# Tampa Electric Company (TECO)
# Coal Yard Assessment
## Stantec Job No. 198800347

September 2010
Revision 2

Stantec has been retained by Tampa Electric Company to provide a review of the coal field equipment at the Big Bend facility. The review scope boundaries are from the dock through conveyors L1 and L2 that bring the coal to the tripper deck in the power house.

PICTURE TTWR-T6-F

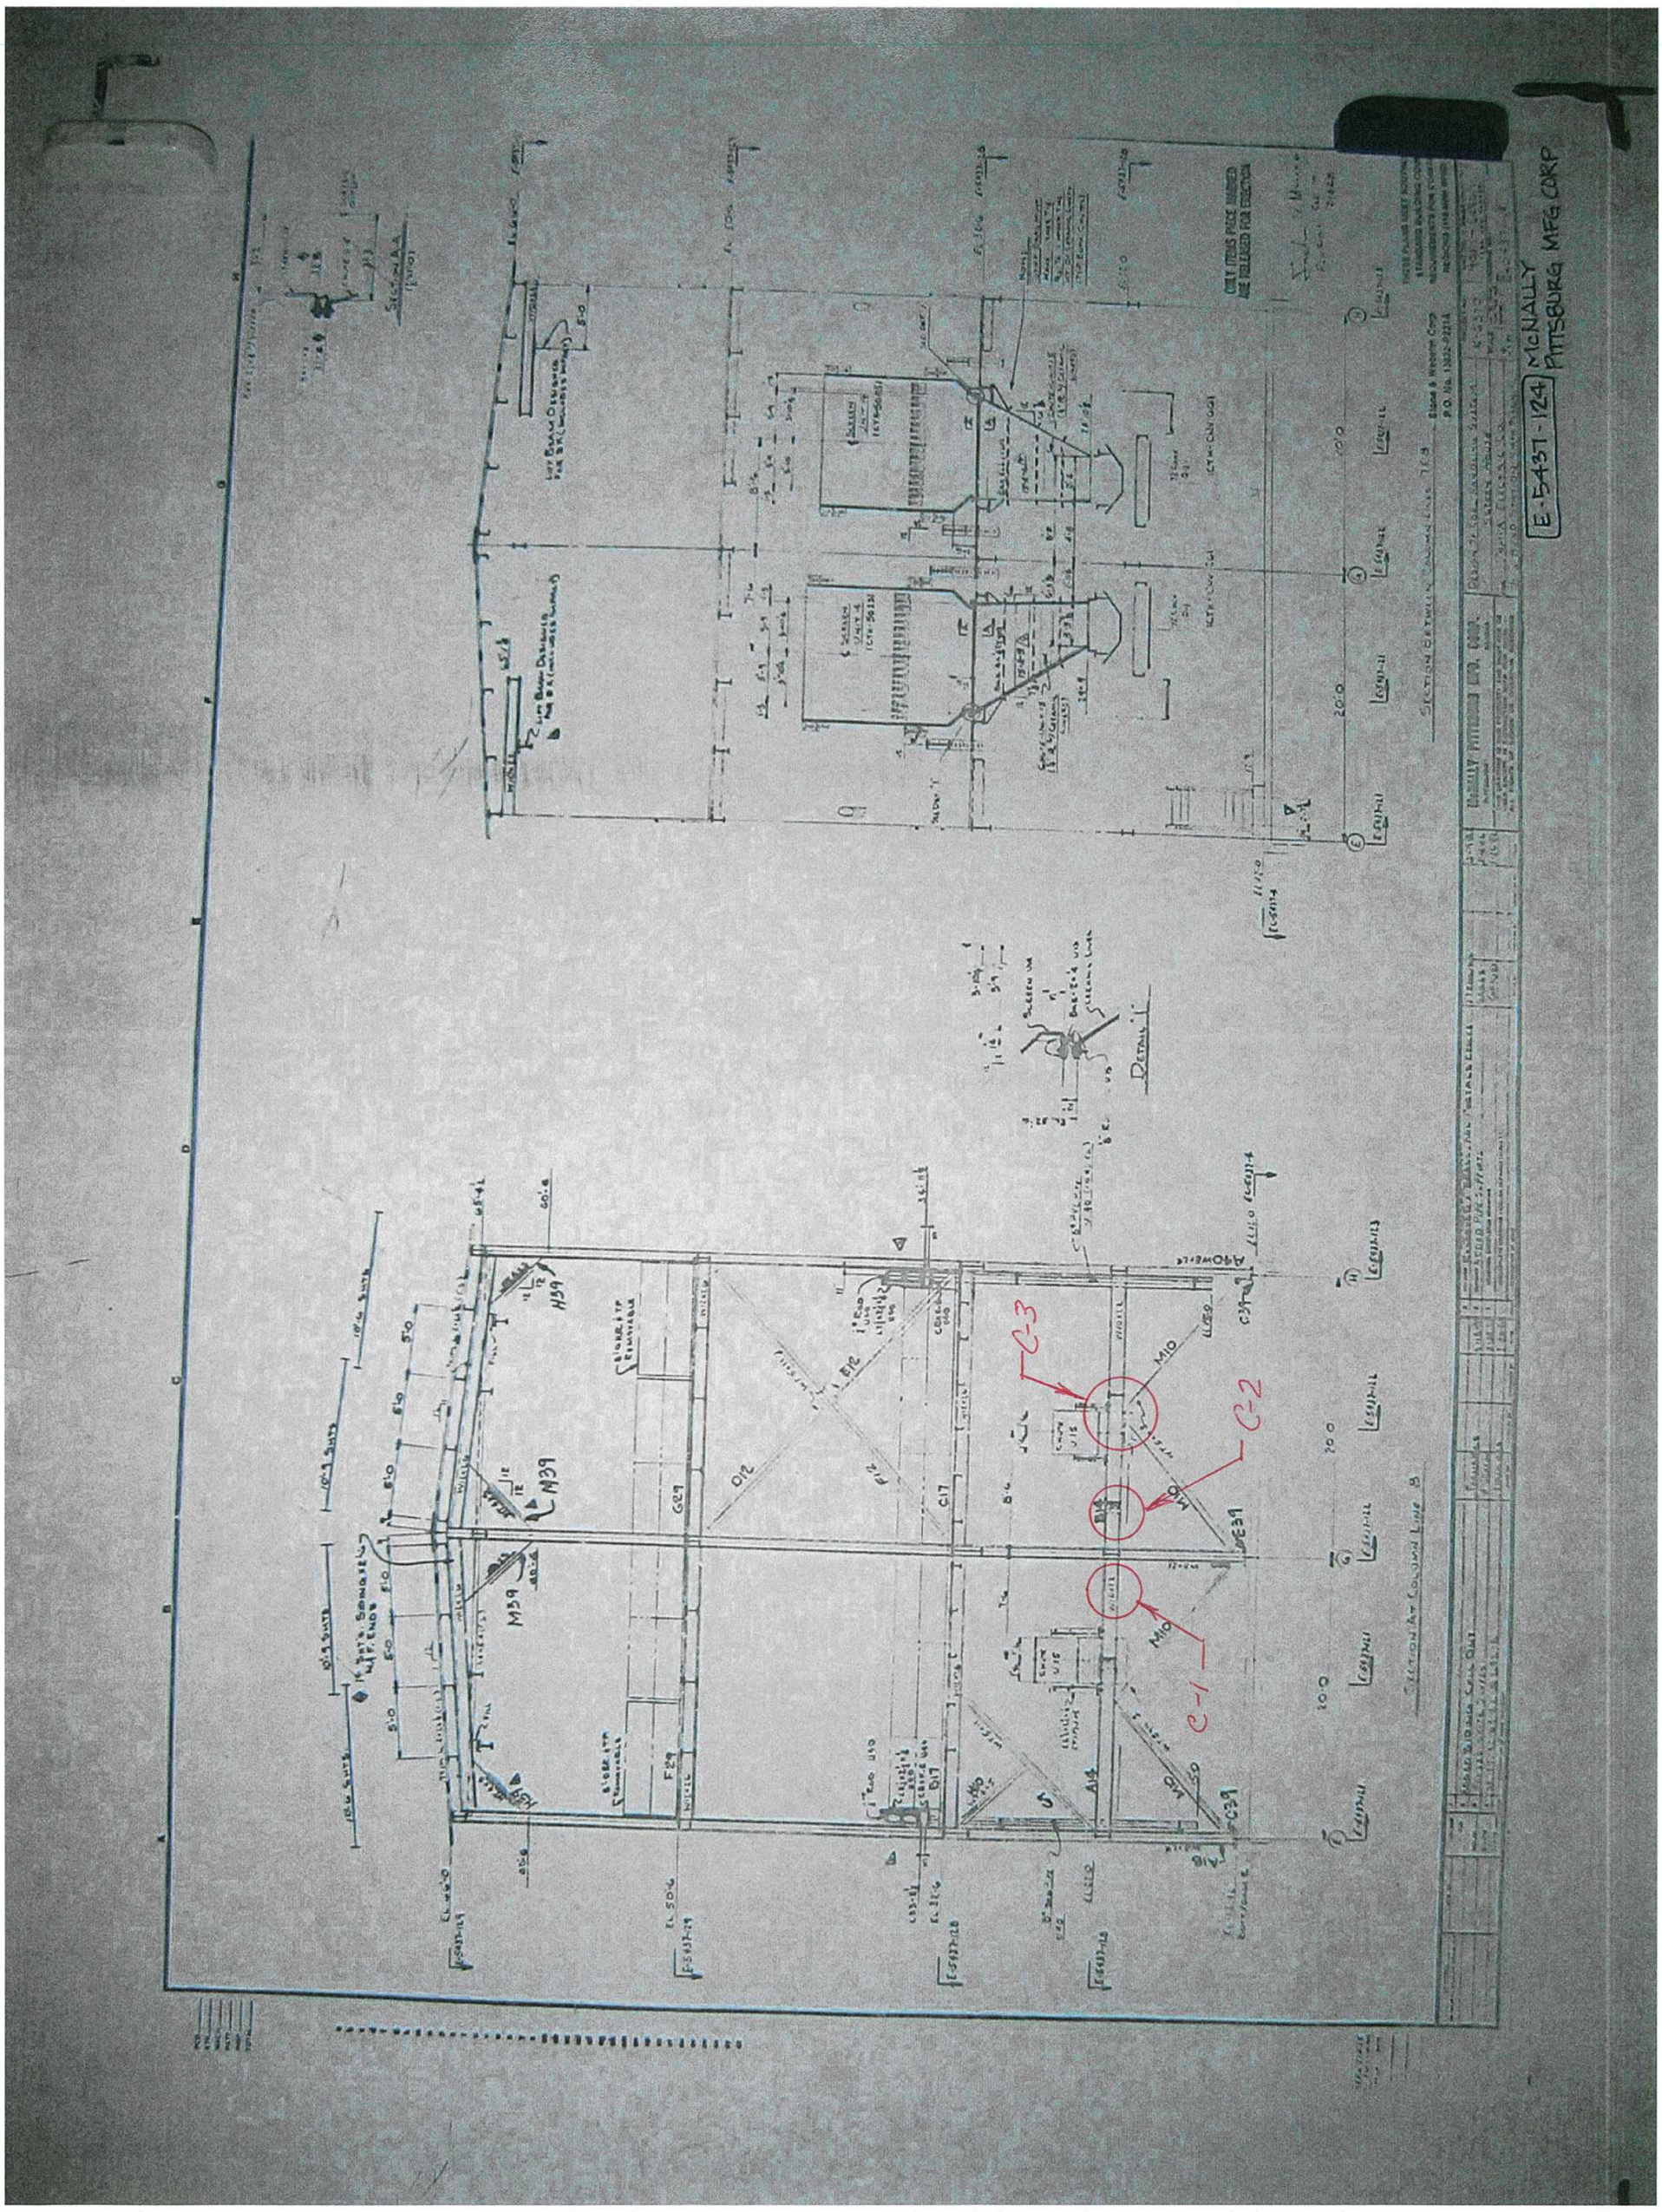
Additionally, pictures TTWR-T6-F and TTWR-T6-G are examples of the condition that the floor framing is in below the grating floor, in part due to the accumulation of coal on the grating mixing with moisture due to rain or humidity.

Stone and Webster Drawing 11473-FS-25A-8

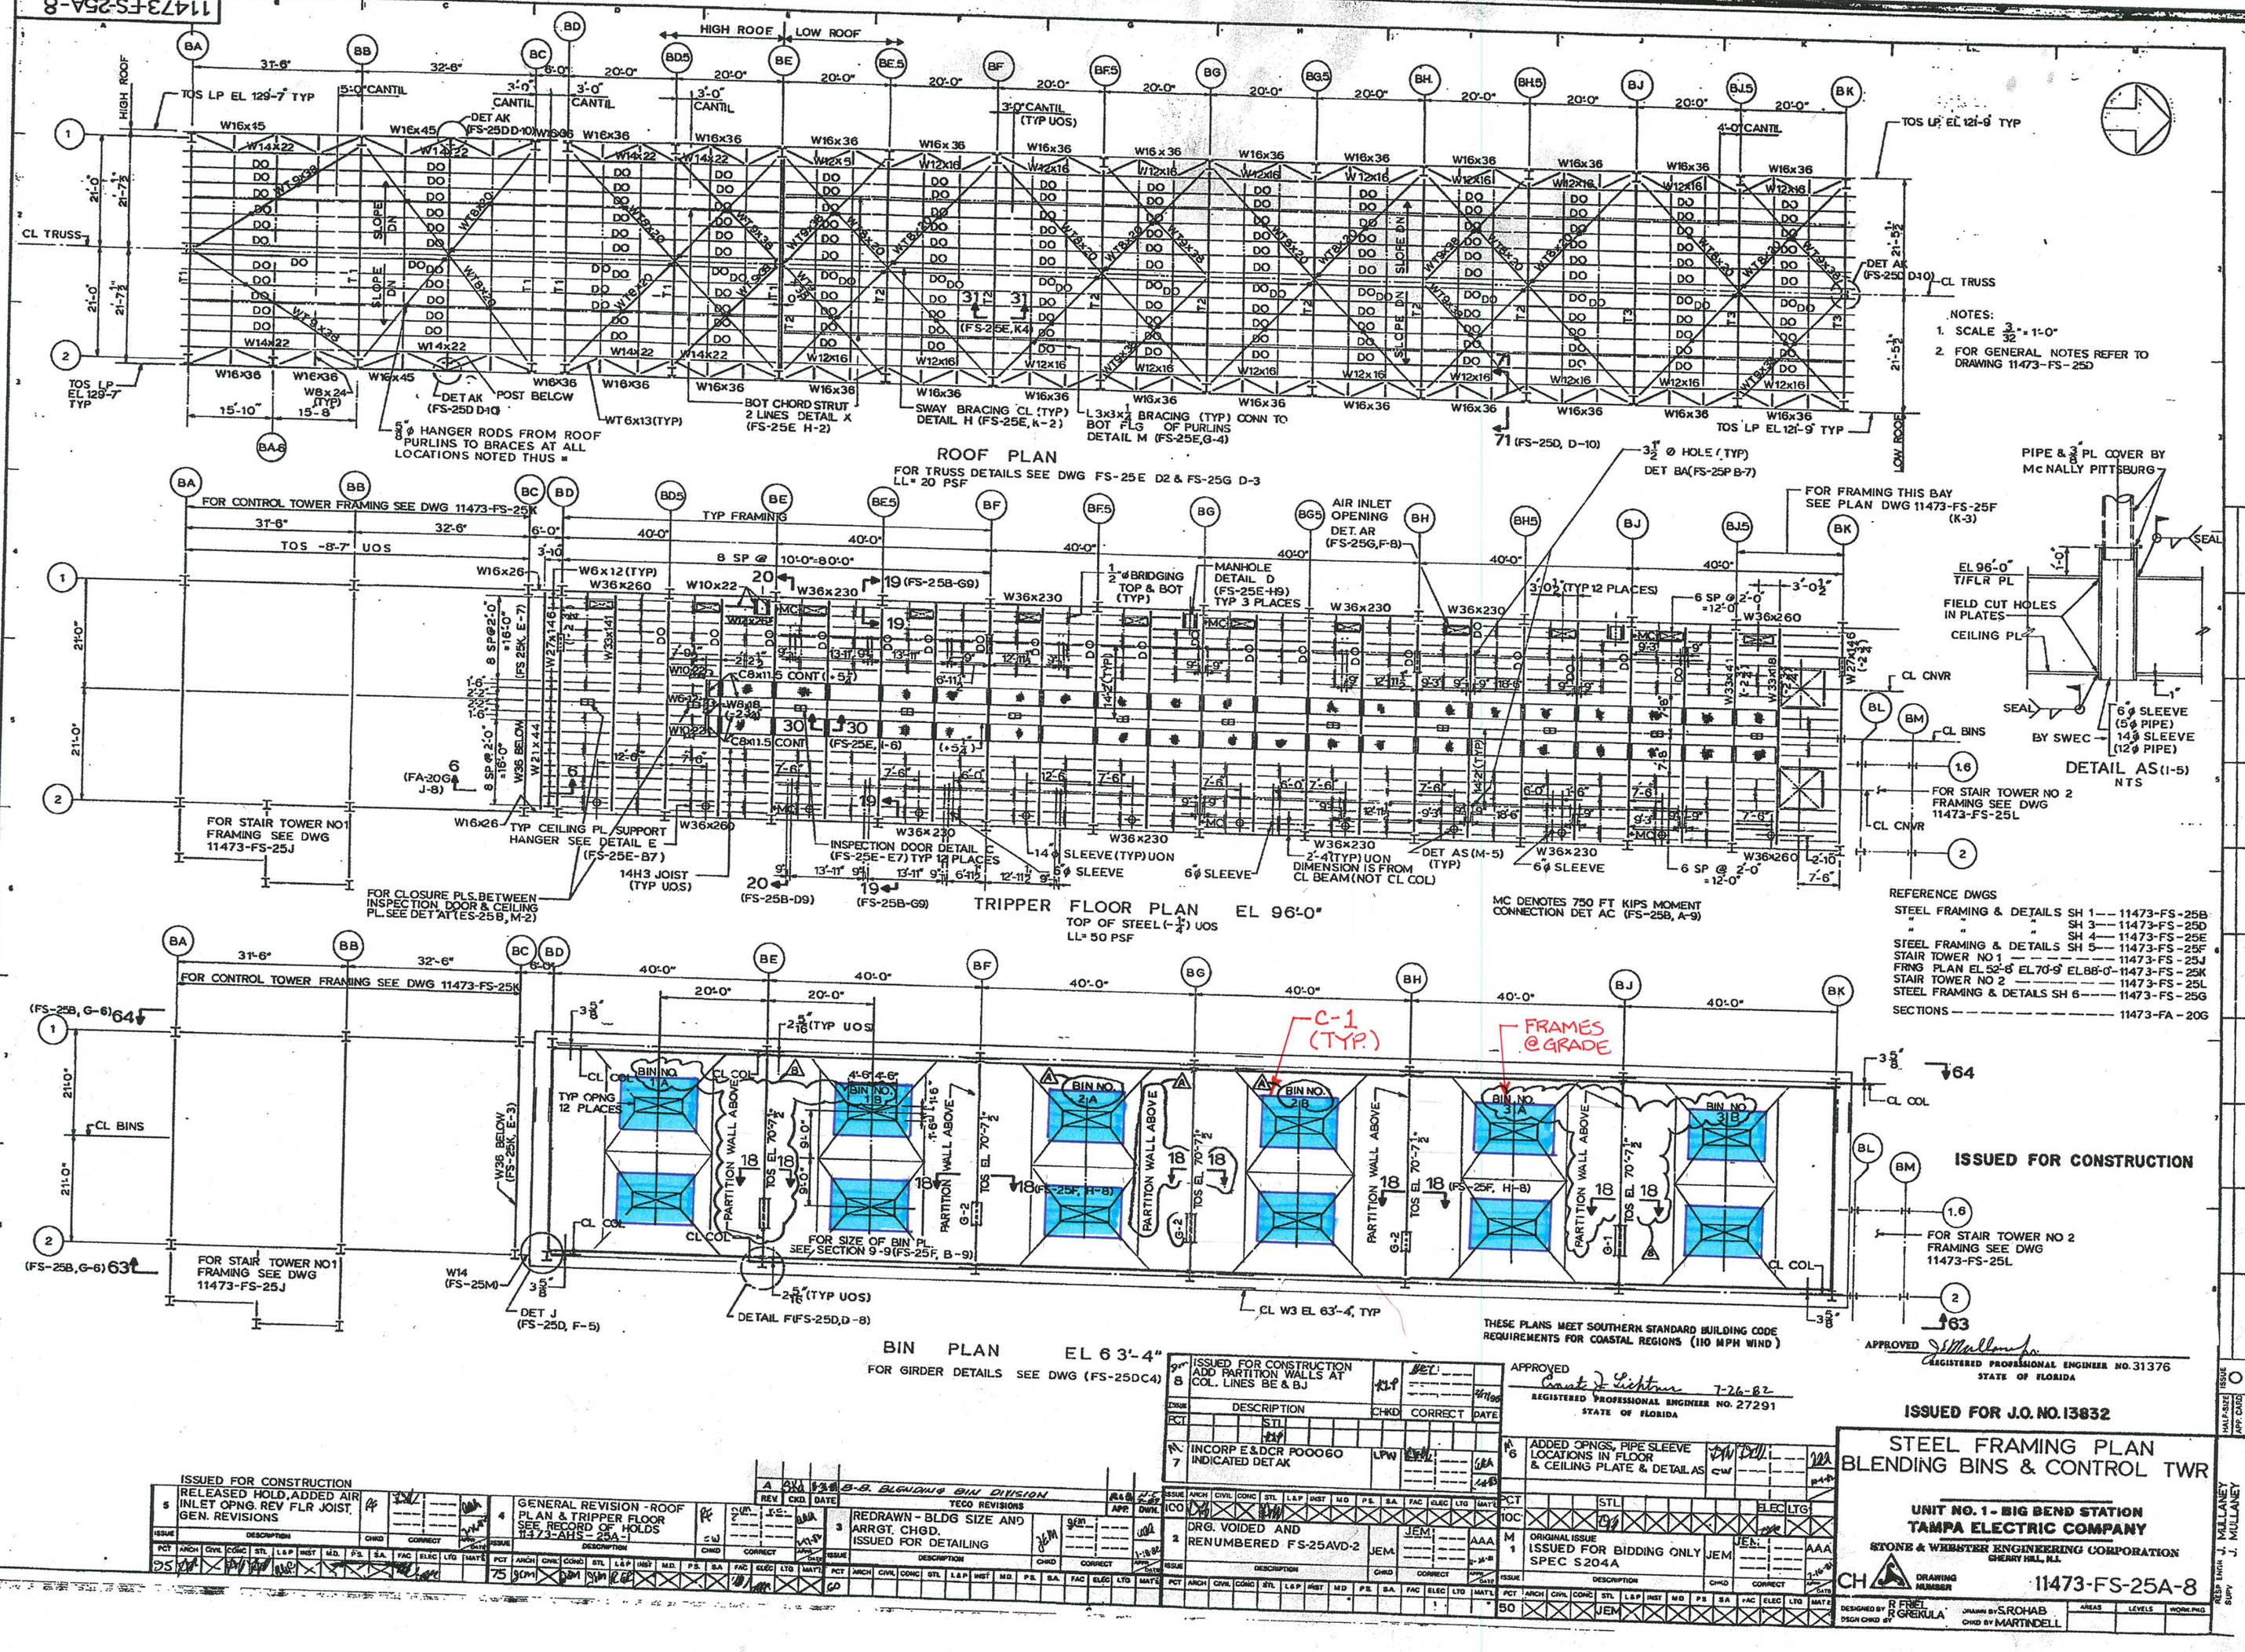
C-1 Support frames for the Gravimetric Feeders have severe corrosion at the column bases. Clean and paint to protect from further damage. The vertical angle braces have severe corrosion and metal loss at connections to columns. Many braces should be replaced in kind and others require cleaning and painting.
